Re: Abengoa Mojave Solar Project (09-AFC-5): Supplemental Written Response to Data Request Set 1B (nos. 1-86)

Soils and Water Resources (21-61)

Application for Certification for the **ABENGOA**)
MOJAVE SOLAR POWER PLANT)

Figure 21-1. Total dissolved solids versus pumping rates for a 5-mile radius around the proposed Abengoa Solar Energy Project site.

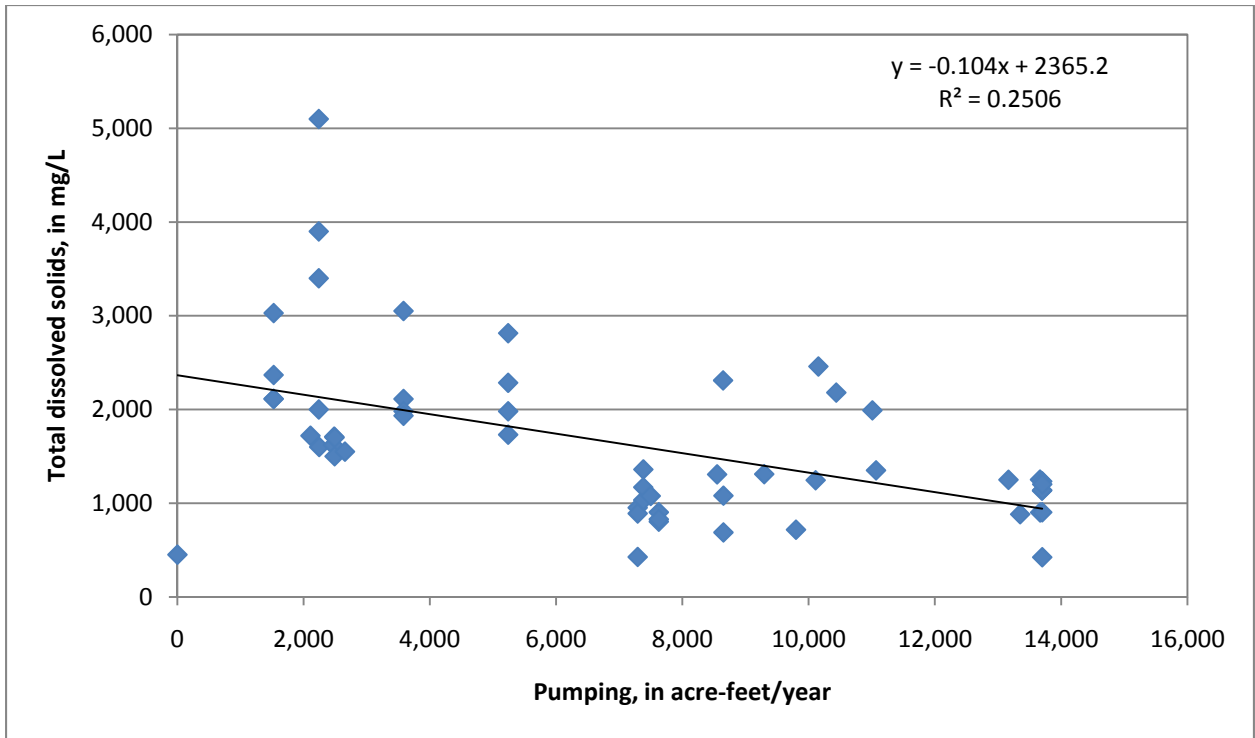
- A. Using available data, please provide a graphical analysis of the historical relationship of groundwater pumping to TDS concentrations at the proposed project site over time.
- B. Similarly, please provide historical groundwater TDS (or electrical conductivity [EC]) data for wells within the Harper Valley Groundwater Basin (HVGB) during the peak decades of pumping for alfalfa irrigation (1950s to 1980s).
- C. Evaluate the data for pumping-induced trends.

- A. Figure 21-1 shows the historical relationship of groundwater pumping to TDS concentrations for a 5-mile radius around the proposed site. A 5-mile radius was chosen for this analysis for two reasons: 1) there is no data available at the project site over the 1950-2009 time period so a larger area was needed to look at the entire time period; and 2) TDS concentrations will be impacted by outsidewells, up-gradient of the proposed site, so including wells that are up-gradient allows for a more complete analysis.

Figure 22A-1. Pathlines originating from Harper Dry Lake (yellow area) to Abengoa Solar Energy Project proposed wells.

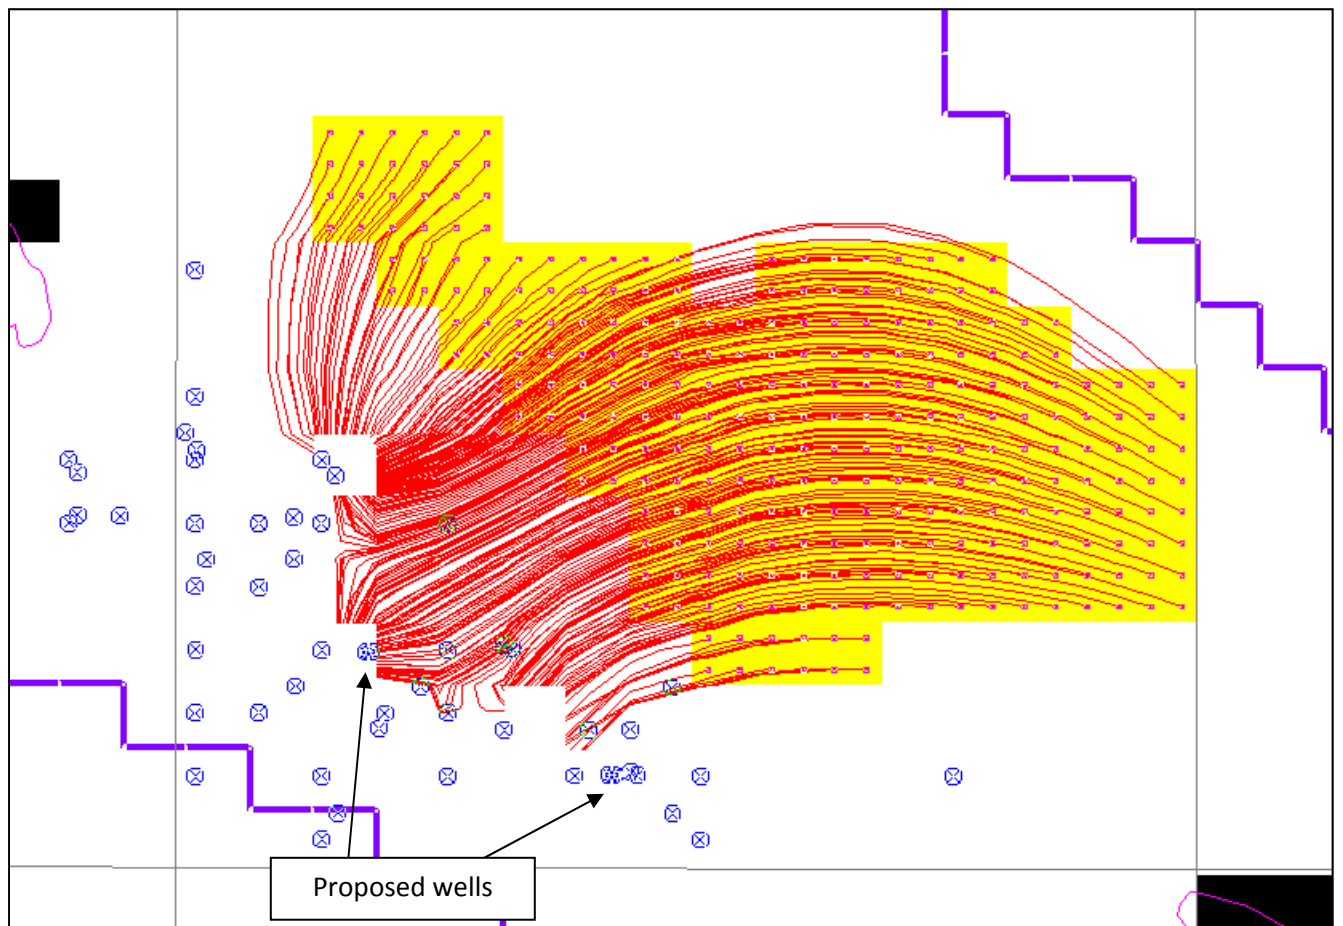
- A. Please evaluate the potential for high TDS groundwater beneath the dry lake to be drawn towards the project's proposed pumping wells. Please use the maximum expected groundwater pumping rate for this evaluation.
- B. Similarly, please assess potential changes in the leakage rate from the perched groundwater table to the deeper water table resulting from the maximum expected groundwater pumping rate.

Please provide results of a MODPATH or similar particle tracking analysis to show the capture zones of the project wells (with simultaneous operation of wells at Luz Solar Energy Generation

System (SEGS) XI and XII power plants) with continuous pumping at the maximum annual production rate for periods of 10, 20, and 30 years.

We used the calibrated USGS model to trace particles from starting points that surround the lake, starting at the beginning of the construction period. The results are shown in Figure 22A-1. In general, both without and with the Abengoa Solar Energy Project proposed wells, water from the Harper Lake area is moving from the Lake towards the wells (Figure 22A-2). However, the water that is moving from the Lake area towards the wells is not all originating as flow from directly under the Lake but some water is coming from up-gradient sources. In response to previous and current groundwater withdrawals in the vicinity of Harper Dry Lake, water levels have fallen sufficiently so that the Lake no longer acts as a boundary condition for groundwater flow. Therefore, although some high-TDS water is probably lost from the shallow sediments underlying Harper Lake, much of the water flows underneath the Lake from up-gradient sources.

As shown in Figure 22A-1, path lines that travel from and beneath Harper Lake terminate in the near vicinity of the proposed Abengoa wells. By tracking particles in the reverse direction from the Abengoa wells, MODPATH predicts that water moves from the southwest, across the Lockhart Fault, towards the Abengoa wells (not shown). These outcomes are understandable, since the Abengoa wells lie within a local region where groundwater withdrawals are locally concentrated. However, the nature of those withdrawals makes it unrealistic to simply eversettrace from the wells.

Figure 31-1. Drawdowns relative to predevelopment (2010) water levels at the end of 2012 (end of construction period) with all existing wells and the Abengoa Solar Energy Project proposed wells pumping.

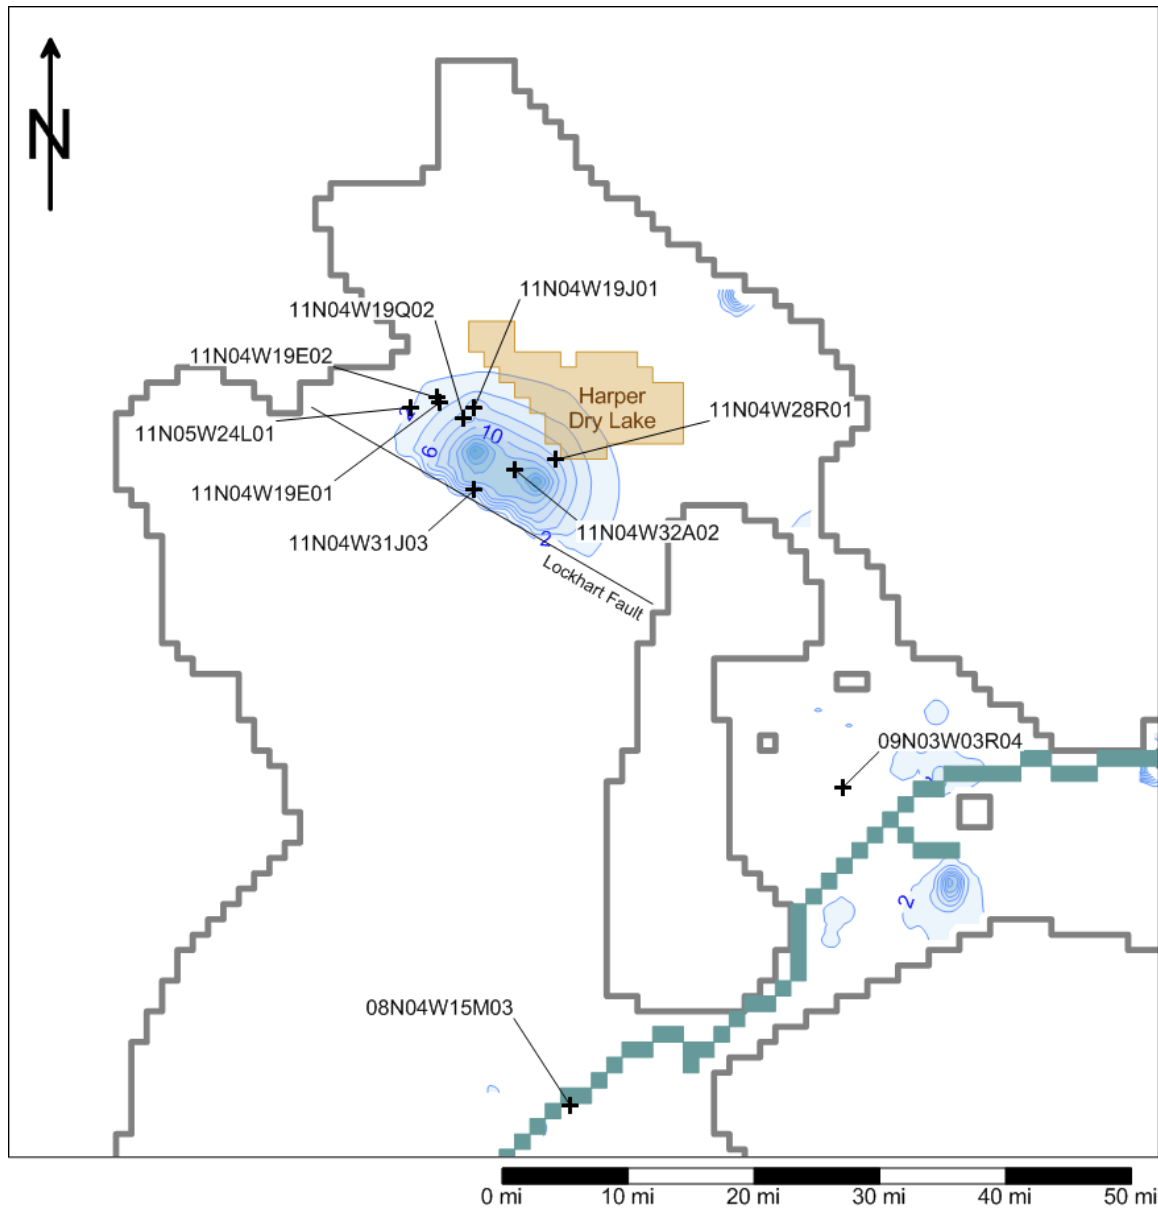
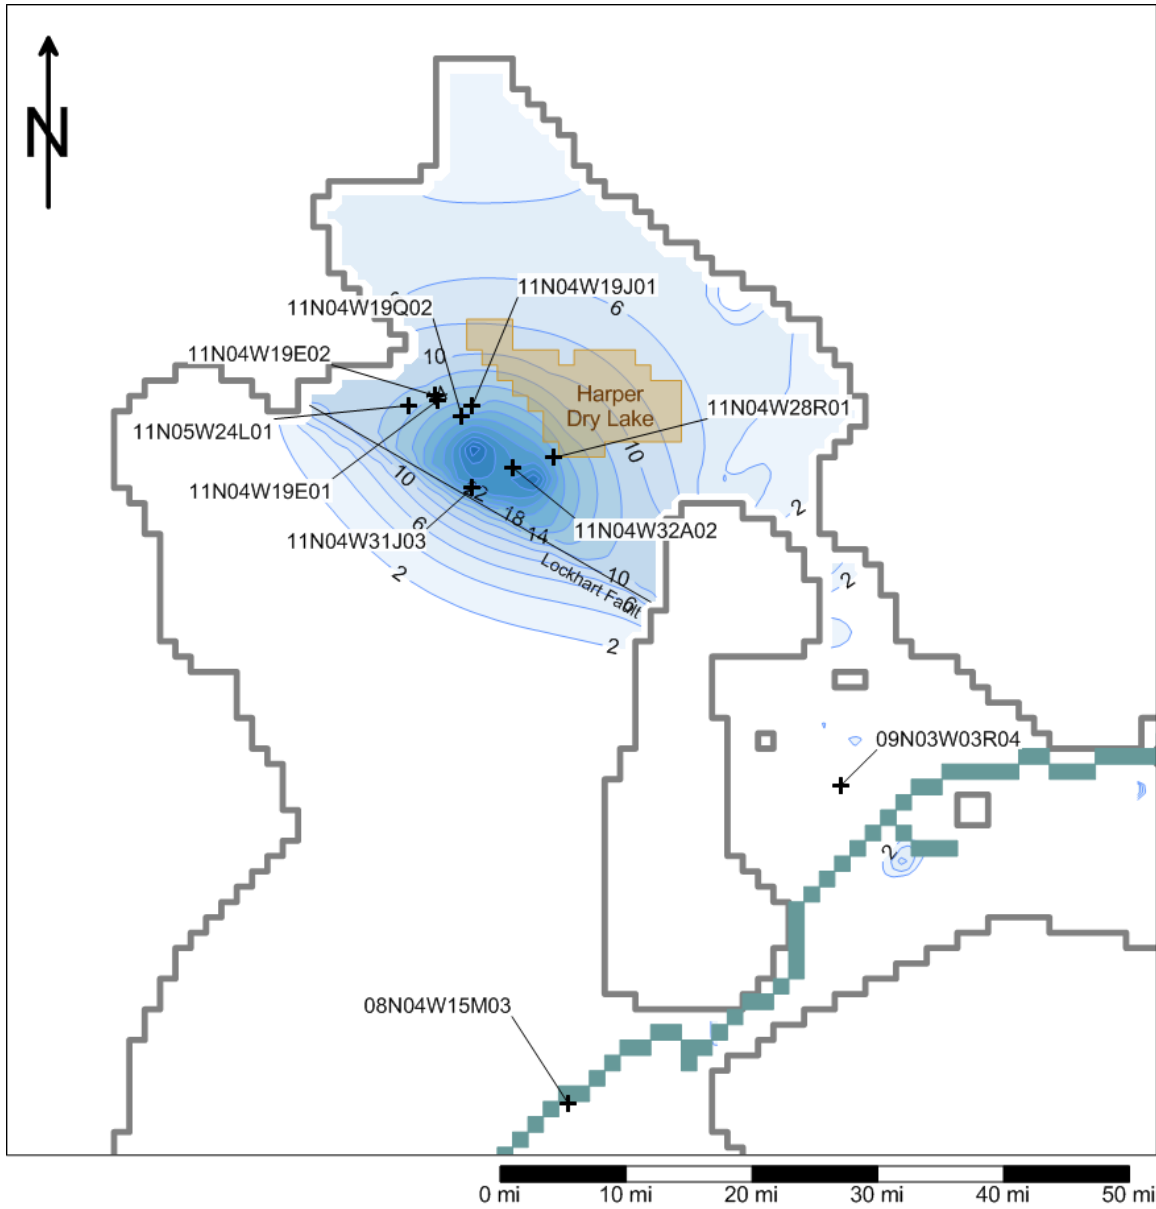
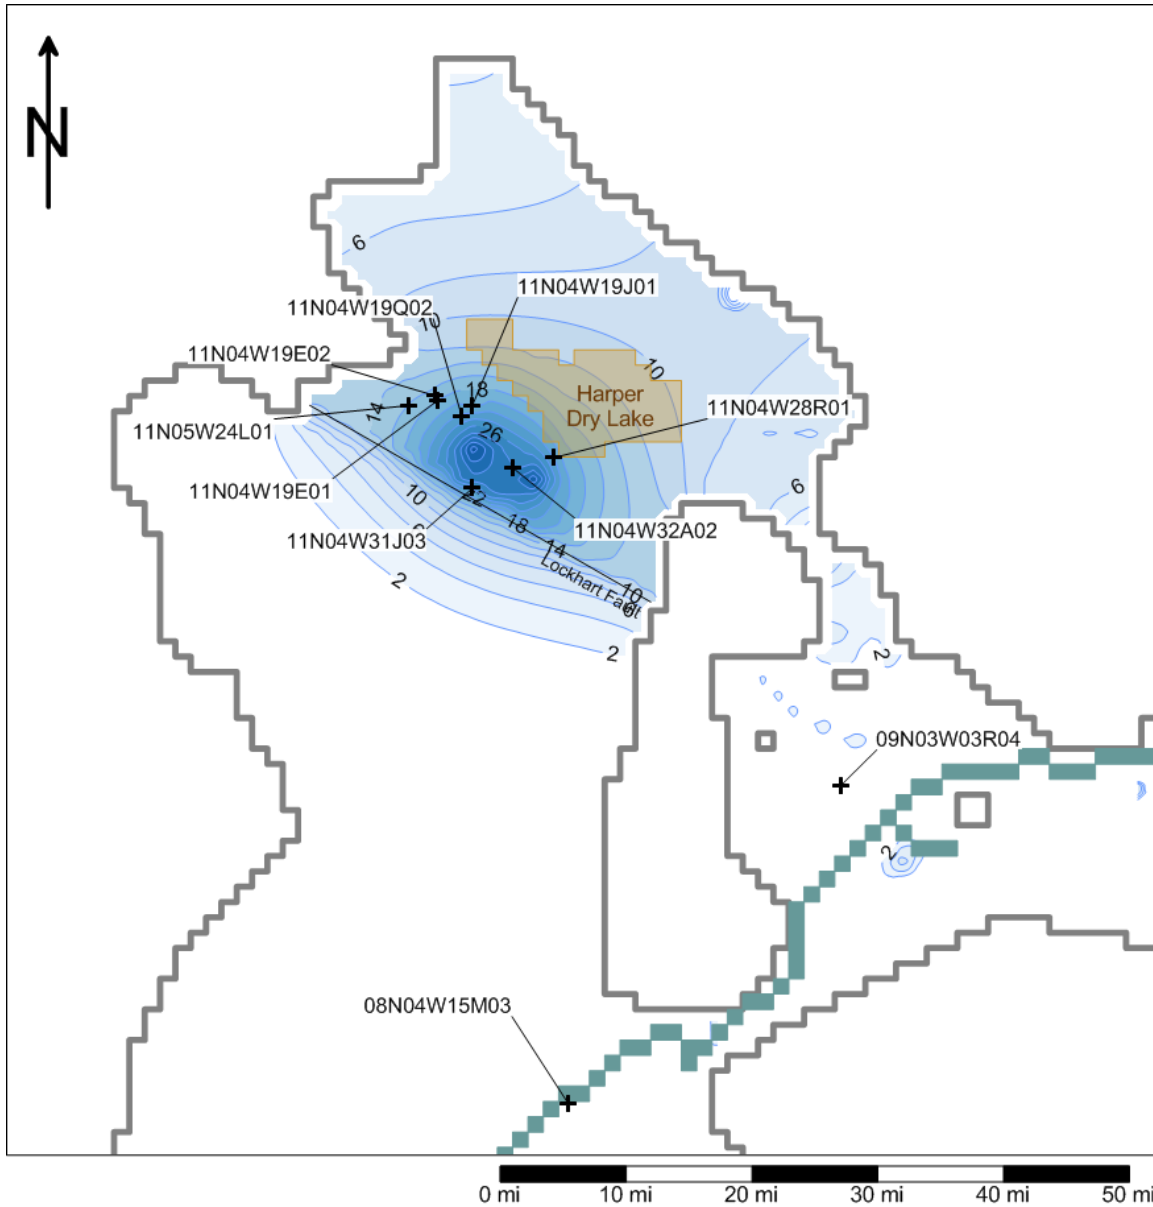
Please provide a revised drawdown and water budget analysis derived from a 640 sq mile basin

Drawdown contours at the end of the construction period (2012), at the end of the operational life of the project (2042), and with a 10% increase in pumping (2042), relative to the predevelopment (2010) water levels are shown in Figures 31-1, 31-2, and 31-3, respectively.

Figure 41A-1: Drawdowns relative to predevelopment (2010) water levels at the end of 2012 (end of construction period) with all existing wells and the Abengoa Solar Energy Project proposed wells pumping.

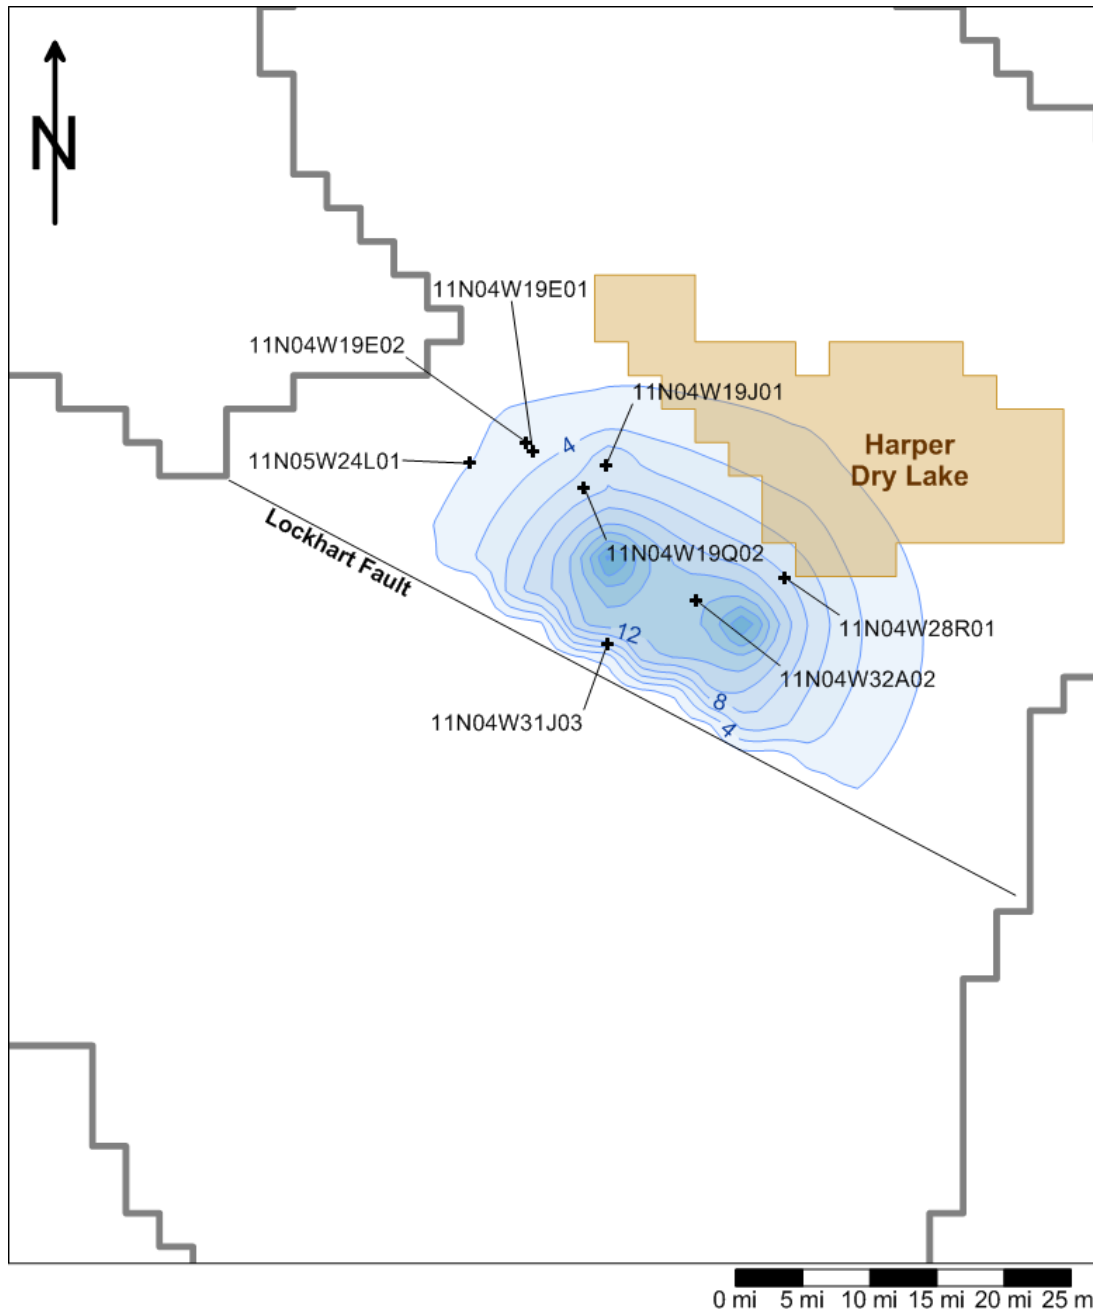
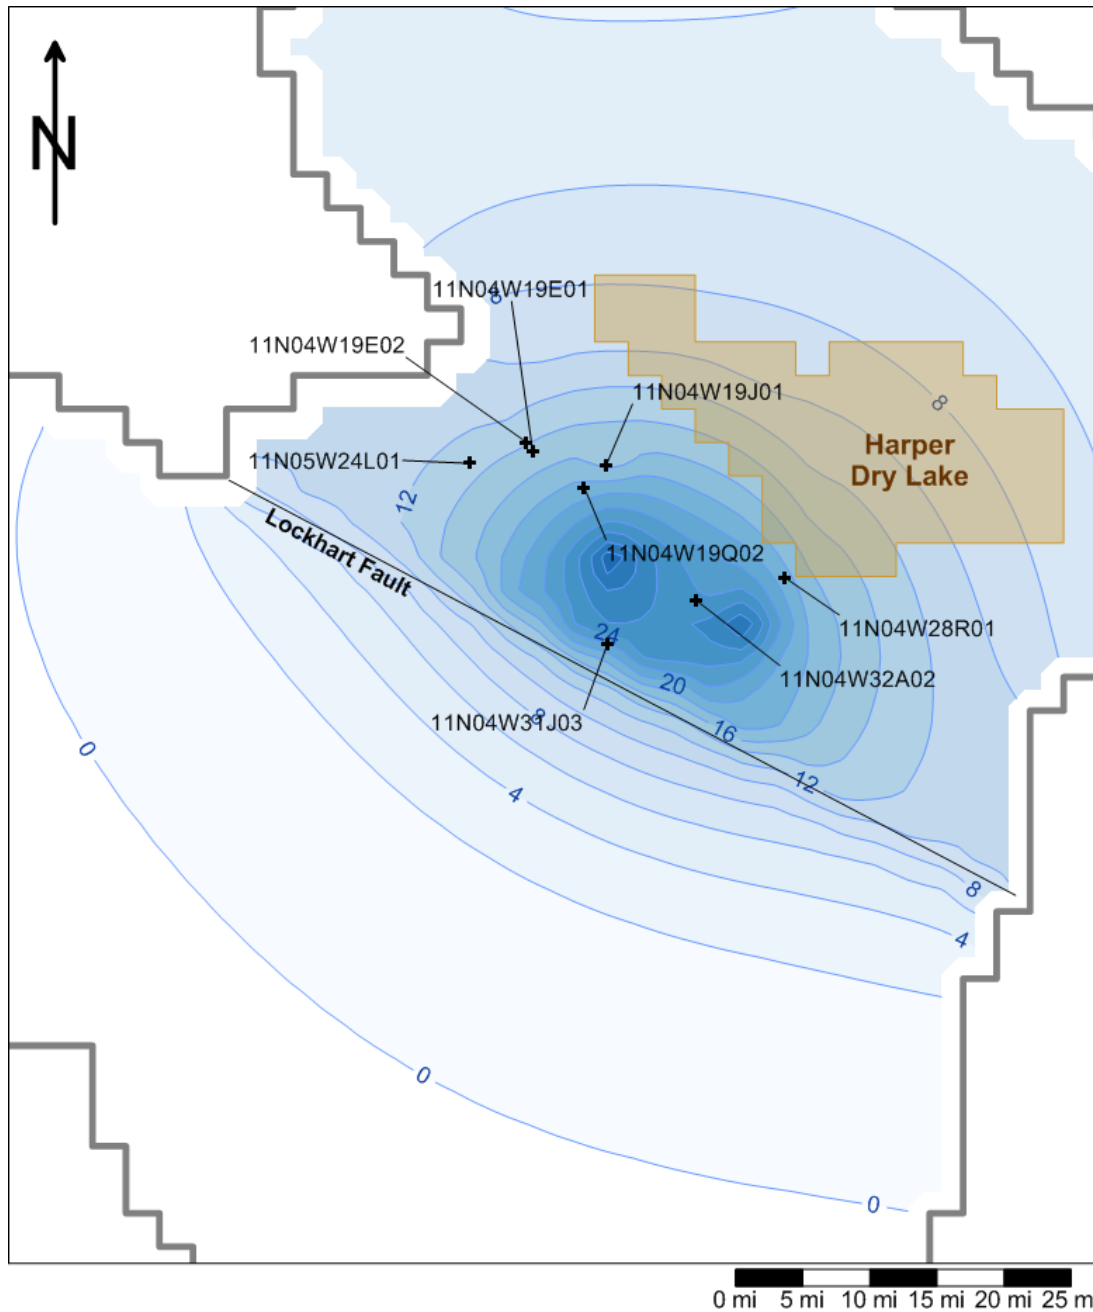
- A. Please conduct a cumulative impact simulation that includes pumping from SEGS VIII and IX supply wells and irrigation, and municipal and domestic wells in the modeled area.
- B. Provide a tabulation of the simulated construction period and 30-year project pumping drawdown at key existing wells shown in *Figure 1-2*.

- A. Our cumulative impact simulation includes all the wells in the HVGB region as provided in the response to Data Request 42. Figures 31-1 and 31-2 show the drawdowns in the HVGB and Figures 41A-1 and 41A-2 show drawdowns in the vicinity of the Abengoa Mojave Solar Project site.
- B. Table 41B-1 provides a tabulation of drawdown at key wells near the project site. Locations of these wells are shown in Figure 41B-1. Hydrographs for these same key existing wells are found in Figures 41B-2 through 41B-6.
